PCN-20210119a TE0713-02 DDR3 Change (Revised)

Company	Trenz Electronic GmbH
PCN Number	PCN-20210119a
Title	TE0713-02 DDR3 and Flash Change
Subject	BOM change
Issue Date	(2021-01-19), Revised 2021-03-09

This change affects all Trenz Electronic TE0713 SoMs of revision 02: TE0713-02-*

#3 Set S/N to not fitted

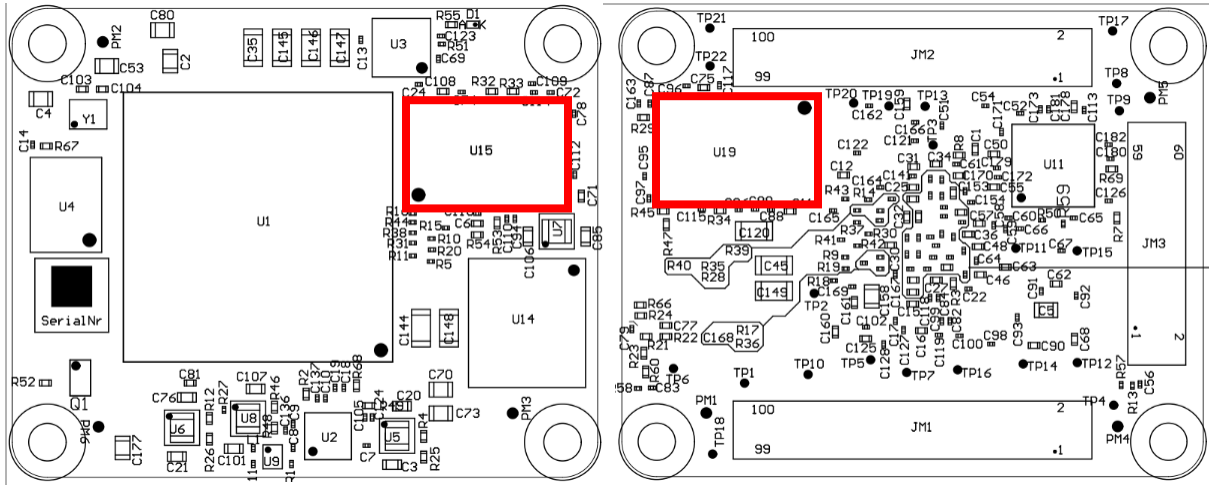
Type: BOM change

Reason: Part is end of life.

Impact: Track it pad no more available.
